BCR601 Errata Sheet

60 V linear LED controller with active headroom control (AHC)

This errata sheet lists a known issue of BCR601 active headroom control in combination with some AC-DC converters used as first stage.

Figure 1 How to implement the workaround in the BCR601 reference design

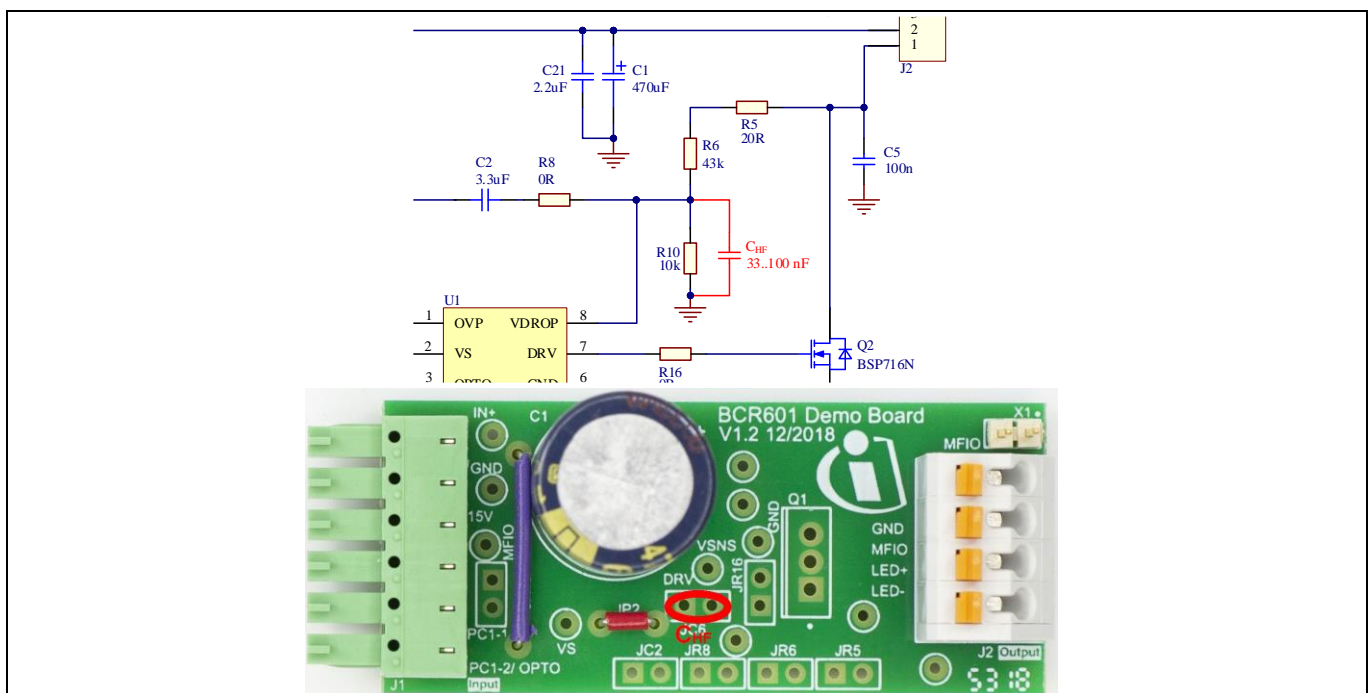
The linear LED driver BCR601 contains two independent regulation loops. One loop is for stabilizing the LED current and the second loop regulates the overhead voltage of the active element of this current regulator, typically a MOSFET. This second regulator was found to become unstable in combination with some AC-DC converters used as first stage.

The mentioned instability is detectable as high-frequency (~ 300 kHz) oscillation at pin 'OPTO' which is pin number three. When the oscillation occurs, the headroom control will not work at all and the output of the error amplifier is typically almost at ground level.

This oscillation occurs when the capacitive load caused by the first stage is below a certain level and can be easily and safely suppressed with the workaround given below.

It is important to understand that this is not an oscillation of the closed feedback loop but of the error amplifier itself. Consequently, it is virtually independent of the values loop compensation components (C2 and R8 of the reference design).

Add a capacitance of 33 nF to 100 nF either from pin 'OPTO' to ground or from pin 'VDROP' (pin number 8) to ground. Although both positions work equally well, the connection from 'VDROP' to ground is recommended and was found to give unconditional stability for the error amplifier. How the additional capacitor can be fitted to the BCR601 reference board is shown in [Figure 1](#).

Note: This workaround does not affect stability of the overall feedback loop. Proper selection of C2 and R8 is still necessary and depends on the AC-DC stage used.
